Notice of Allowability

10/780,283

BRENNFLECK, MATTHIAS
MICHAEL

EXAMINER'S AMENDMENT

Fig. 8

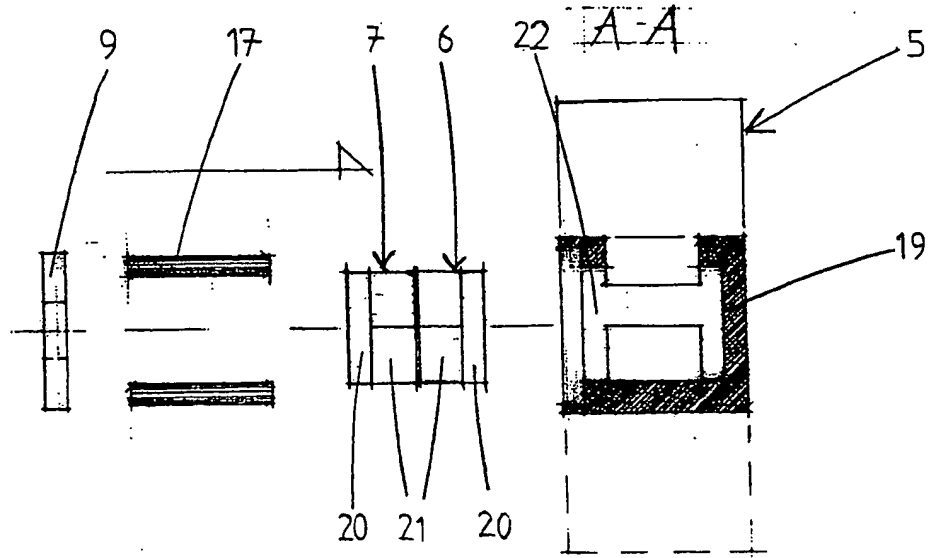
Figures 6-8: The cross hatching for the various sectioned components will all be shown with clear metal cross-hatching (as in Figures 12 and 13) and any superfluous and

unnecessary lines need to be removed from these figures. Figure 8, needs to be treated as an exploded view having brackets to show association.

JK → ~~Fig 9~~

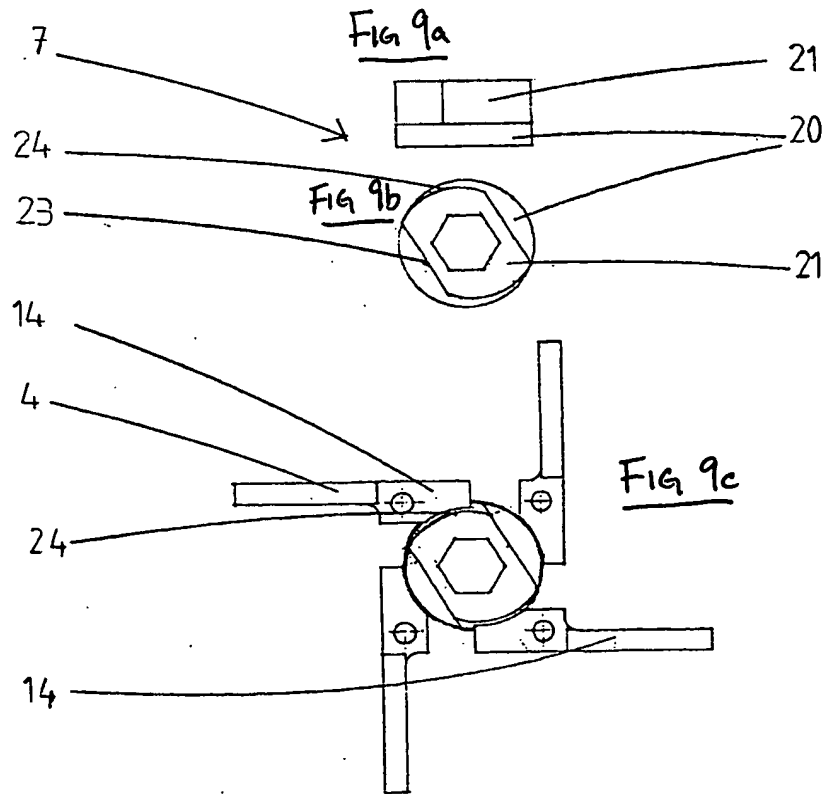
Figure 9: There are 3 views of the same feature of the apparatus in one figure. Figure 9 has been deleted and replaced with three separate figures (9A-9C; See attached Examiners Figure) for each of the three views shown in the instant Figure 9.

-- [0026a] Figure 9a: A side view of the eccentric.--

-- [0026b] Figure 9b: A top view of the eccentric.--

-- [0026c] Figure 9c: A diagram of the eccentric and lateral legs in active connection.--
